**Merged Document Report****Application No.: PL8721**

Document Filename
260707 Saratoga Ridge U2 Plat.pdf

FINAL PLAT OF SARATOGA RIDGE UNIT 2

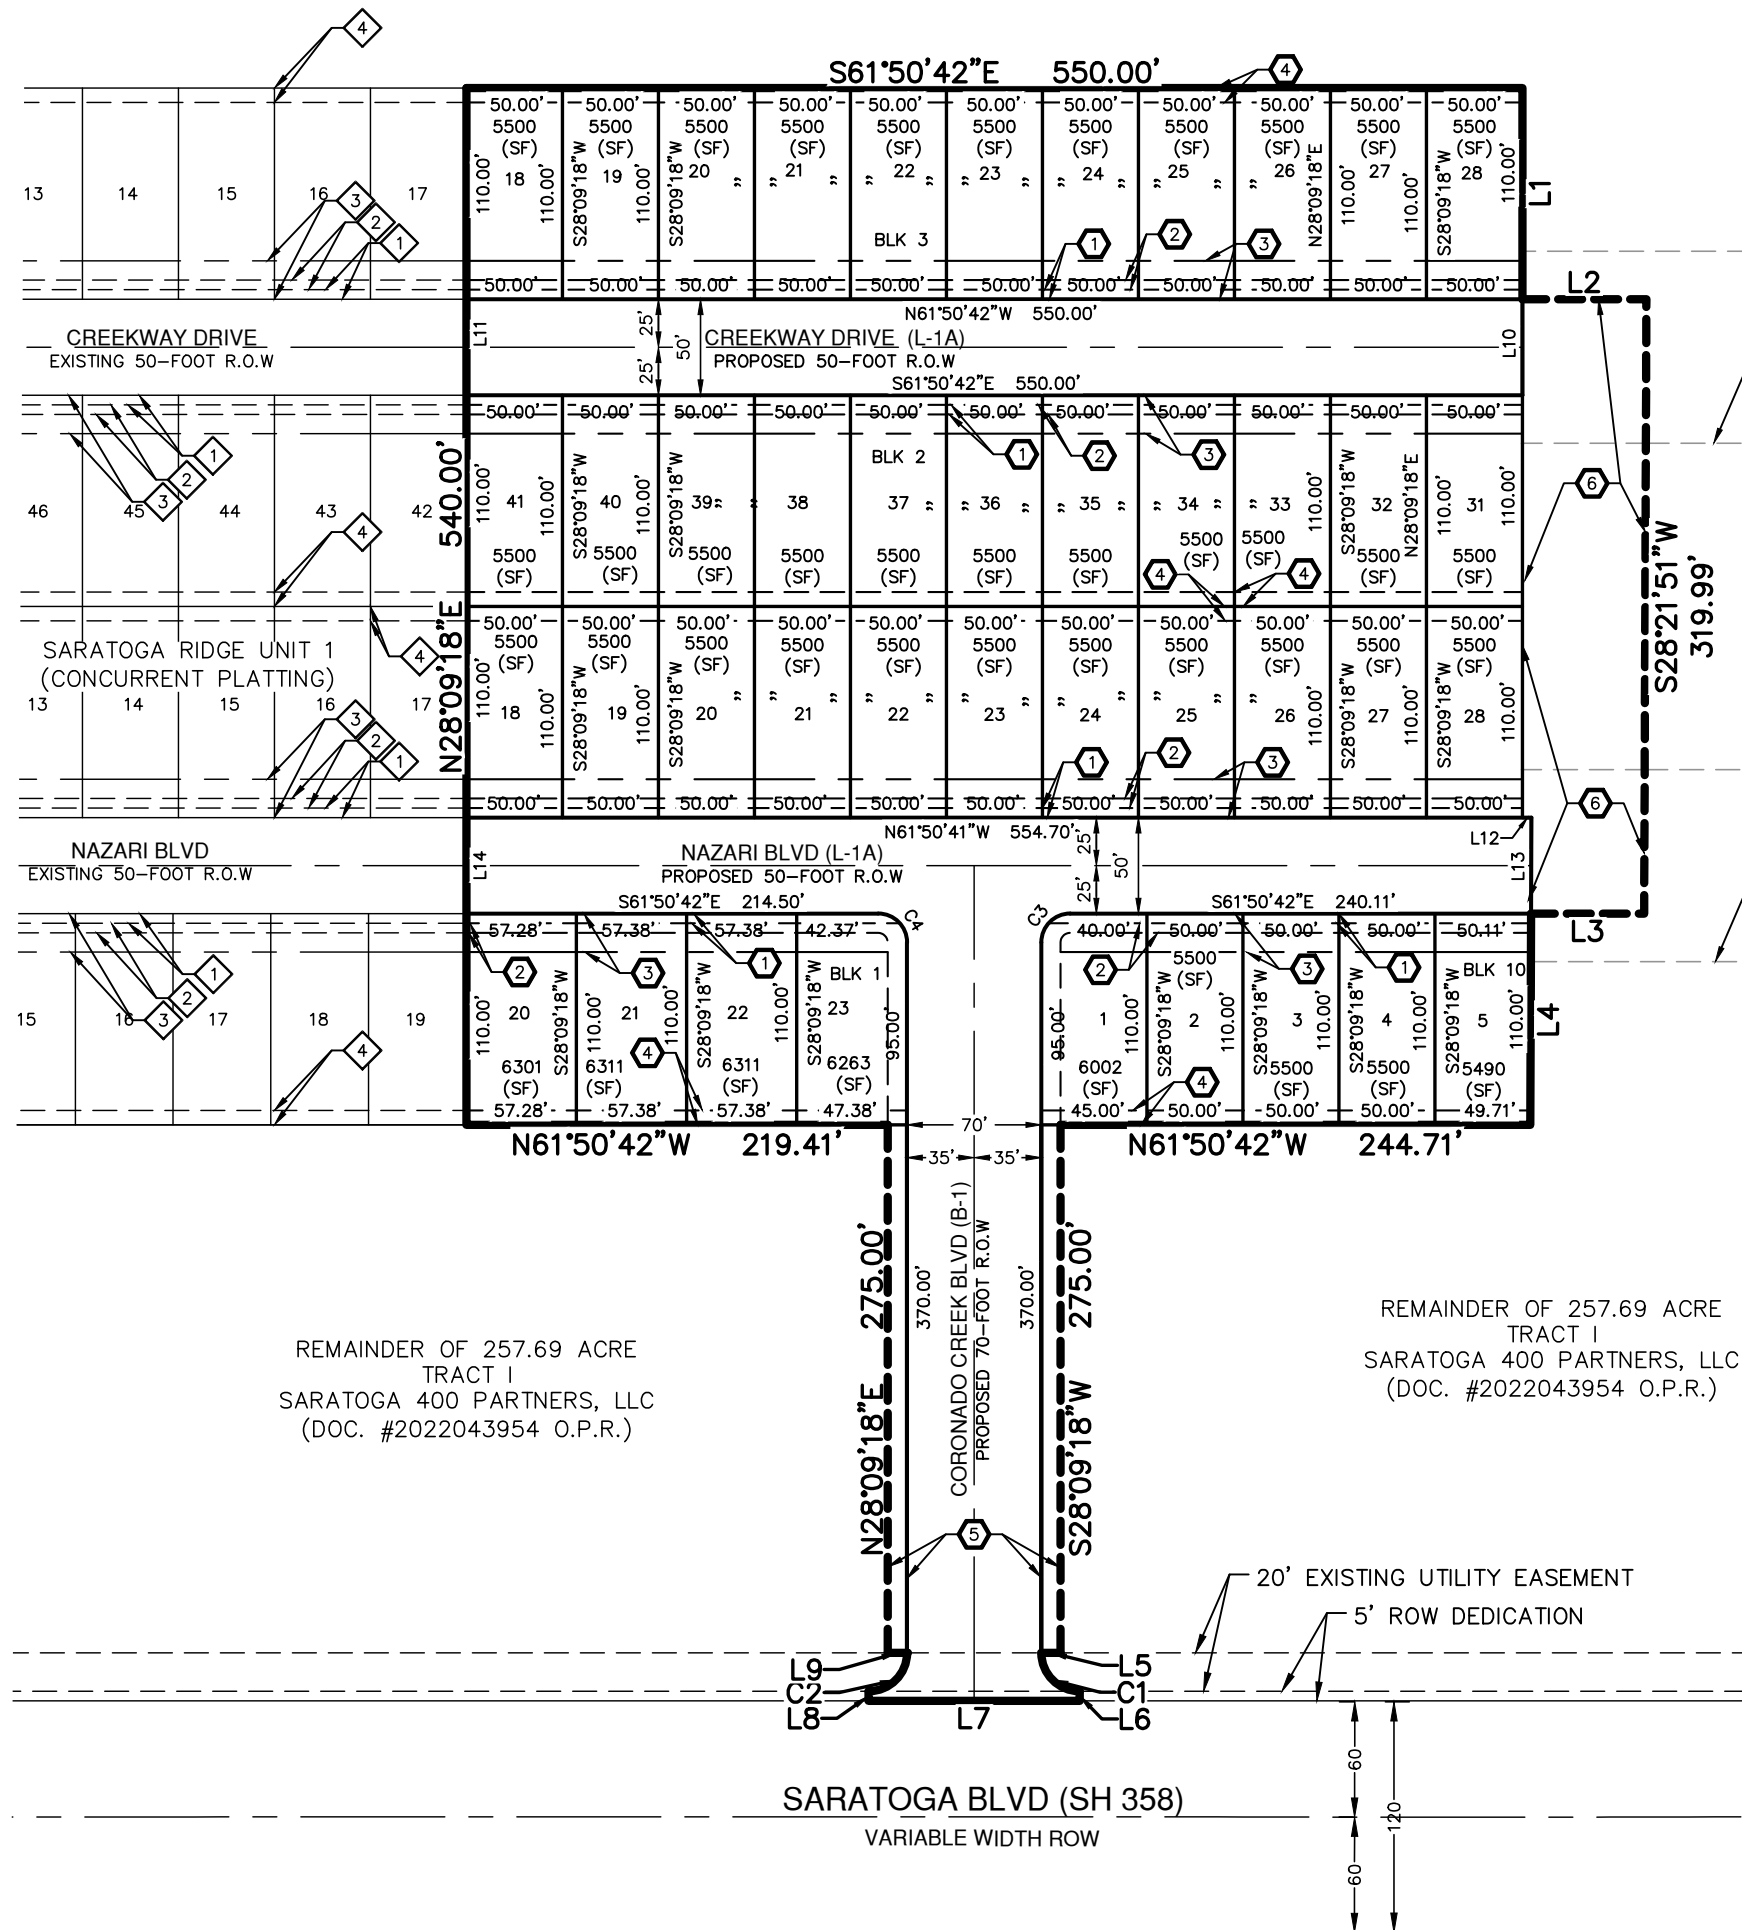
5	PL210	Note	Mark Zans : LD	Closed	Plat is a final plat. Must go to PC	
6	PL210	Note	Mark Zans : LD	Closed	This plat is on the 30-day tract for approval, approval with Conditions, or disapproval by 6/25/2025. The deadline for revisions to be submitted is 6/16/2025	
7	PL210	Note	Mark Zans : LD	Closed	The plat will be recommended as Conditional Approval for Resolution comments received and that have remained Open and unmet.	
8	PL210	Note	Mark Zans : LD	Closed	A request or response may be made for an additional 30 days for Public Notice plat with a Waiver or to resolve Open comments. This request must be made directly to Development Services within the 30-day initial period.	
10	PL210	Note	Mark Zans : LD	Closed	Please change the road name. Road A is not acceptable name.	
11	PL210	Note	Mark Zans : LD	Closed	Please label lots with square footage amounts.	
12	PL210	Note	Mark Zans : LD	Closed	Are there lot or tract designations for these boxes? Please label area as to use.

13	PL210	Note	Mark Zans : LD	Closed	Are there lot or tract designations for these areas? Please label area as to use.	
14	PL210	Note	Mark Zans : LD	Closed	Label as lot or tracts	
15	PL210	Note	Mark Zans : LD	Closed	Label as lots or tracts.	
16	PL210	Note	Mark Zans : LD	Closed	TxDot comments: Please add the below 4 notes regarding access/drainage onto the state roadway system.

18	PL210	Note	Mark Zans : LD	Closed	Please clearly define the shape of the plat in the location map.	
19	PL210	Note	Mark Zans : LD	Closed	GIS comment - Current plat configuration does not close to acceptable engineering standards. Please clearly define the plat boundary by using a darker, thicker plat boundary line and providing curve and line tables for the boundary on the appropriate sheets.	
20	PL210	Note	Mark Zans : LD	Closed	Park fee: \$462.50 x 42 lots = \$19,425	
21	PL210	Note	Mark Zans : LD	Closed	Traffic comments - Informational only. 1Informational:Proposed driveway access to a public City Street shall conform to access management standards outlined in Article 7 of the UDC (UDC 7.1.7) 2Informational:Proposed driveway access to a public maintained by the Texas Department of Transportation (TXDOT) shall conform to TXDOT criteria. The developer and/or agent is responsible for coordination with the local TXDOT Area Office. 3Informational:The PW-Traffic Department(Right-of-Way Division) is responsible for reviewing and
